D) Remarks

Applicant's Comments re Claim Objections

Applicant's Comments re Drawings

FIG. 8

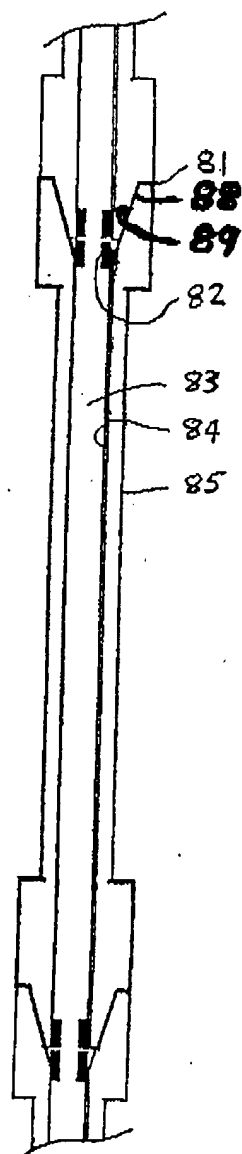
The drawings are objected to as failing to comply with 37 CFR I .84(p)(5) because they do not include the following reference sign(s) mentioned in the description: 86. A proposed drawing correction or corrected drawings are required in reply to the Office action to avoid abandonment of the application. The objection to the drawings will not be held in abeyance.

Applicant acknowledges that reference sign 86 is mentioned in the description twice in the first full paragraph on page 10 of the application as filed, and is not found in any of the drawings. Applicant further notes that reference signs 87, 88 and 89 are also mentioned in the description and are not found in any of the drawings.

Missing reference signs 88 and 89 are added to FIG. 8, as marked on the enclosed informal drawing "replacement sheet" 3/9 enclosed herewith. First and second sealing faces 88 and 89 are both mentioned in the first full paragraph on page 10 of the application. Therefore, these corrections add no new matter.

The two occurrences of "mandrel 86" in the description constitute typographical errors. They are amended above to read "mandrel 83". The occurrence of "cable 87" is also a typographical error. It is amended above to read "cable 84". Applicant notes that mandrel 83 and cable 84 are both mentioned in the first full paragraph on page 10 of the application and are both identified in FIG. 8. Therefore, these amendments add no new matter.

Applicant respectfully requests that the drawing correction indicated by informal drawing "replacement sheet" 3 of 9 be accepted.
